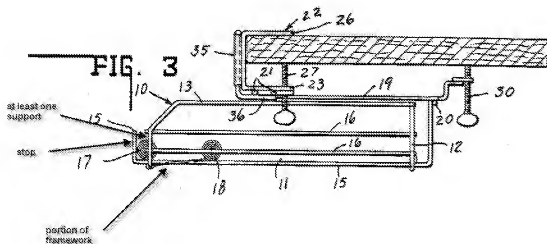
Claim 56 is rejected under 35 U.S.C. 102(b) as being anticipated by Dickson (US 3007580). Dickson discloses a shelf structure configured to rest on and engage a shelf, the shelf structure comprising:

a front member 21 and at least two other members 21, 20 rearwardly spaced from the front member and, together with the front member, defining a first plane above the shelf and configured to support additional shelving above the first plane;

a framework 15 defining a second plane disposed below the first plane and configured to support a plurality of beverage containers between the first and second planes;

and at least one support (labeled below) connecting at least the front member and the framework;

wherein at least a portion of the framework (labeled below) extends at least forward of a projection of the front member 21, the projection including with a stop (labeled below) extending in a direction from the second plane toward the first plane; and

members 23 on the front and at least one of the other members configured to fix the framework under another structure.

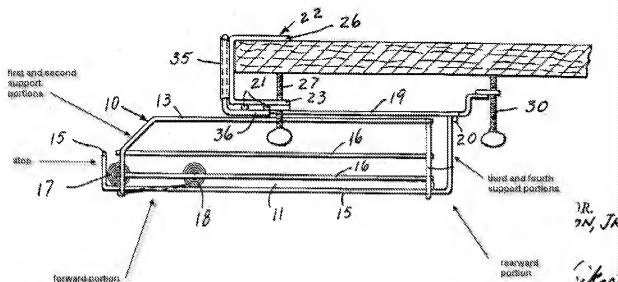
Claims 57 and 59 are rejected under 35 U.S.C. 103(a) as being unpatentable over Dickson (US 3007580) in view of Lockwood (US 4732282). Dickson discloses a shelf fastened under a structure 32 by fasteners 27, the shelf comprising:

a support assembly having a forward portion (labeled below) and a rearward portion (labeled below), the support assembly defining a support surface (not numbered, but shown in figure 3) configured to support a plurality of cylindrical beverage containers;

a stop (labeled below) disposed at the forward portion of the support assembly;

first and second support portions (labeled below) disposed at the forward portion of the support assembly, the first and second support portions including upper ends, respectively, adapted to be disposed above the plurality of cylindrical beverage containers supported on the support surface;

at least first and second apertures (not numbered, but comprising the apertures for the fasteners 27) disposed adjacent the upper ends of the first and second support

portions, respectively, the first and second apertures being configured to receive fasteners 27 for supporting the forward portion of the support assembly from a structure 32 above the support assembly, the first and second apertures being spaced rearwardly from the stop;

third and fourth support portions (labeled below) disposed at the rearward portion of the support assembly, the third and fourth support portions including upper ends, respectively;

at least a third aperture (not numbered, but shown as the aperture for the fastener 30 in figure 3) disposed adjacent the upper ends of the third and fourth support portions, respectively, the third aperture being configured to receive a fastener 30 for supporting the rearward portion of the support assembly from a shelf above the support assembly; and

wherein the third aperture is spaced from a rearward most portion 20 of the rearward portion of the support assembly such that cylindrical beverage containers can be placed onto the rearward portion of the support assembly when the third aperture is connected to a shelf disposed above the support assembly by fasteners;
